# UNITED STATES PATENT AND TRADEMARK OFFICE

<b>Office Action Summary</b>	<b>Application No.</b> 10/698,134	<b>Applicant(s)</b> GENICK, RAYMOND M.	
	<b>Examiner</b> Leonard J. McCreary, Jr.	<b>Art Unit</b> 3616

## **DETAILED ACTION**

**Figure A.** Bolt is fixed in angularly arbitrary horizontal position; 3-axis vertical mill with ball end mill used to machine channels having parallel faces.

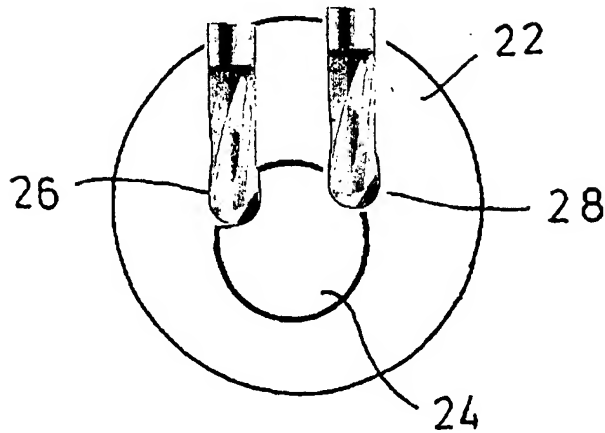
- a threaded fastener 1 defining a pair of longitudinal channels 18, 20, each channel defining a generally flat bearing surface and a concave curved portion, said generally flat bearing surfaces being generally parallel. (Figures 1-3, 6) (Figure A below) (col 4, lin 3-5)
- a non-threaded portion 10, 12 of the fastener 1
- a first cam plate 8 non-rotatably coupled to the non-threaded portion 10 of the threaded fastener 1
- a second cam plate 22 Figure 3 defining an aperture having a pair of generally flat aperture bearing surfaces, at least one generally flat bearing surface being in contact with at least one generally flat bearing surface, said aperture being non-rotatably mated to the pair of longitudinal channels 18, 20
- the rotational position of the first and second cam plates with respect to each other is fixed (col 1, lin 36-40) (col 2, lin 5-7)

Examiner maintains that the rejection is proper, because it would have been obvious to one of ordinary skill and creativity in the art to construct the cam assembly taught in Fig 3 of Hofschneider similarly to that which is claimed in the present application, so as to improve manufacturability by machining the channels with a ball end mill on a standard 3-axis mill with the bolt fixed in a single horizontal position and wherein angular orientation of the channels about the longitudinal axis of the bolt becomes irrelevant.

See Fig. A below.
